**Correspondence Between
Staff and Applicant
Approval Letter**

**City of Scottsdale
Stormwater Management**

Drainage Review Memorandum

Re: Silverstone Parcel "G"
Case number: 9-PP-2017

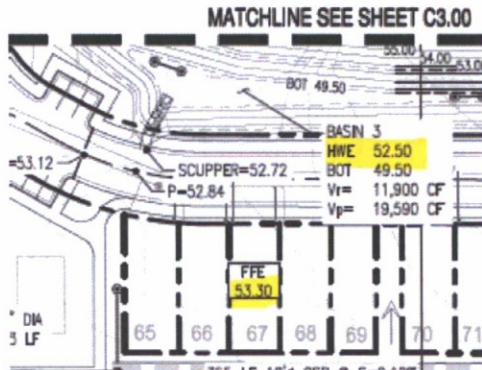
5. 1st Review: Please review and revise proposed FF elevations to be compliant with section 5.0 of preliminary drainage report. Some structures have less than identified 12” of freeboard from retention basin high water level.

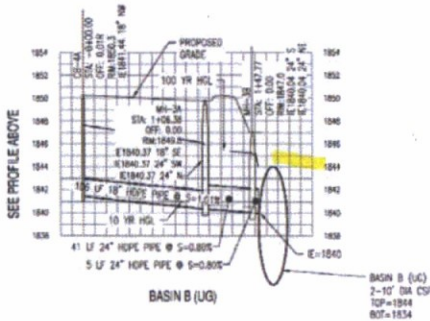
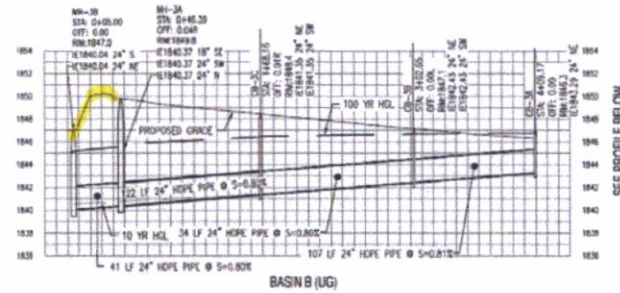
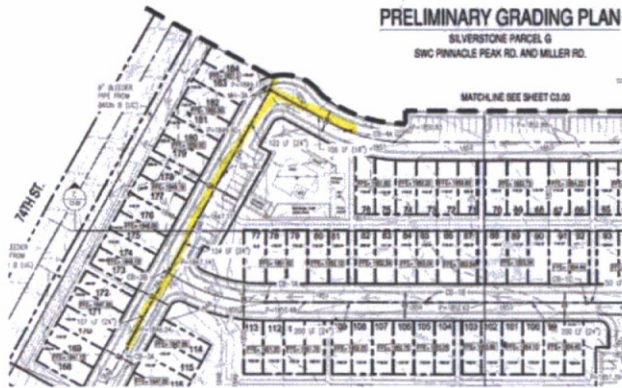
7. 1st Review: Profile all 18" or greater diameter storm drains. Depict HGL in profile view.

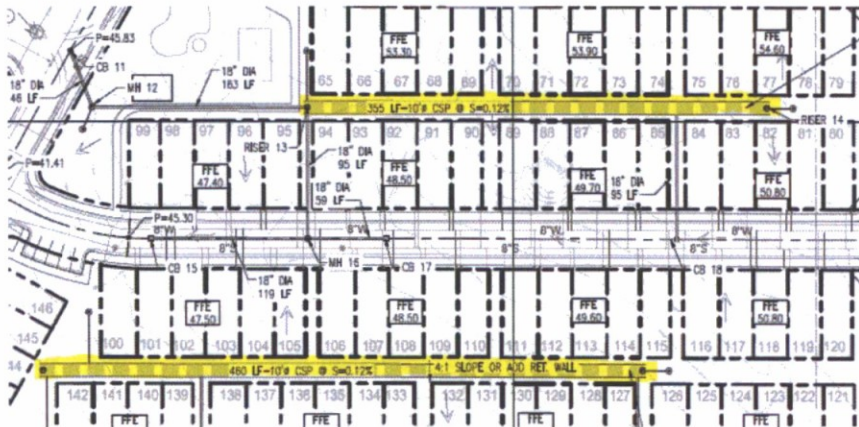
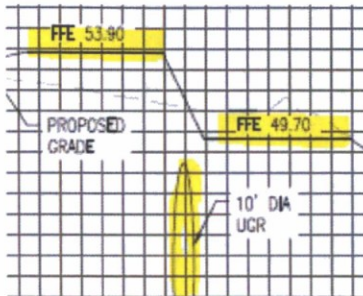
2nd Review: Review profiles to ensure that improvement plan sheets match storm drain profiles. Profile for Basin B (UG) has number of discrepancies when compared to storm drain alignment depicted on the plan sheets. See mark-up on the C sheets.

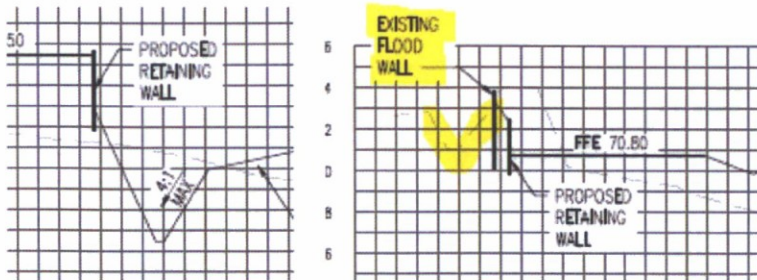
8. 1st Review: Based on the review of preliminary grading and drainage plan it appears that proposed layout does not comply with the City Underground Stormwater Storage Policy. The underground storage areas must be accessible and provide easement with 5 feet of clearance. The site plan will need to be revised to reflect this. The city recommends the proposed underground storage be placed in open space areas. The storage systems placed between houses will not be allowed. No trees, bushes or other major landscaping work will be allowed over underground storage tanks.

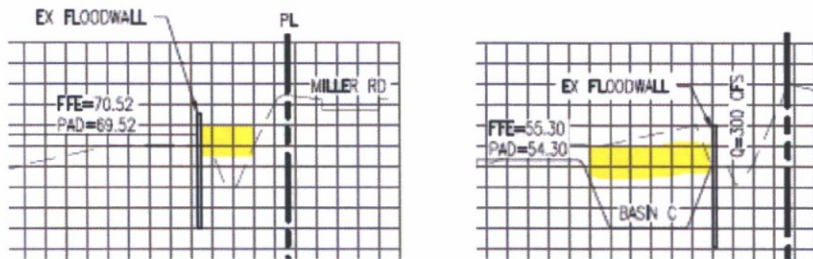
9. 1st Review: Depict HWL in all swales and/or adjacent washes in profile sections. Consider adequacy of existing food walls. What is flow, velocity and scour depth in highlighted wash section below?

- 2nd Review: Missing HWL labels on sections B-B and C-C

2nd Submittal (C3.10)

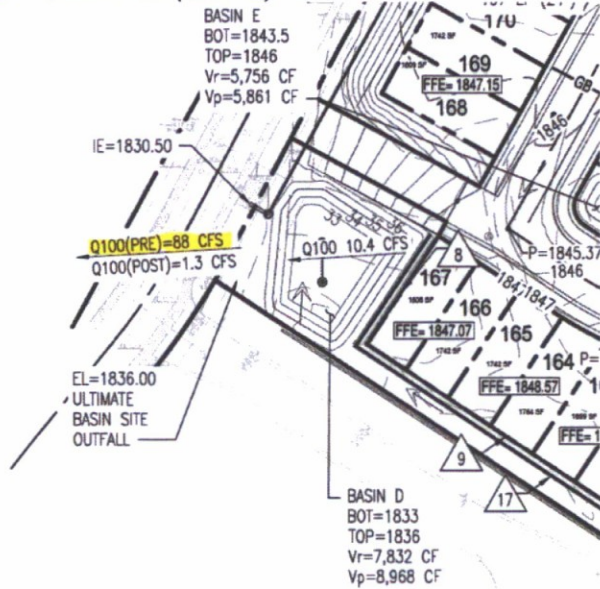
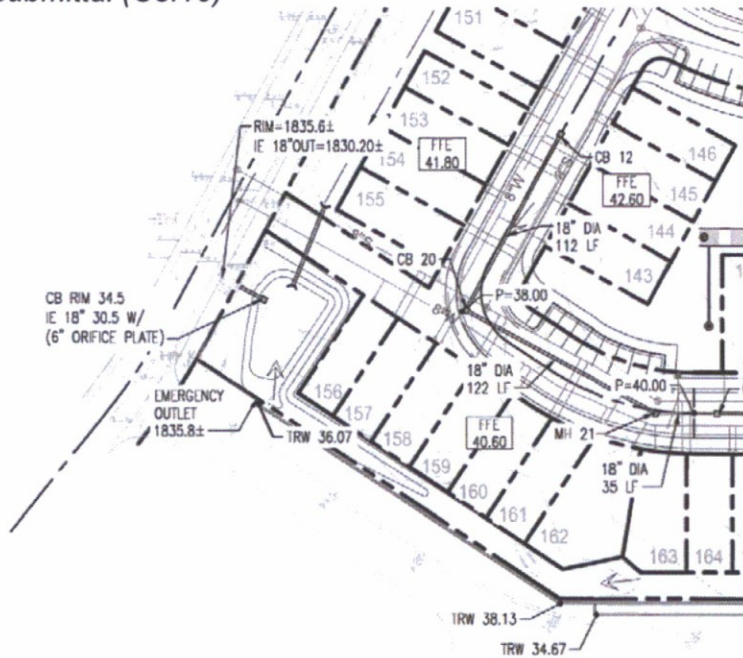
2nd Review: Section 3.6 of drainage report discusses pre development flow of 50 cfs, however sheet C3.10 identifies 88 cfs. What is 50 cfs based on? Include all supporting hydraulic analysis upon re-submittal. Please review and revise for consistency. Depict pre and post development flows along project site southern limit on Post Development Drainage Area Map.
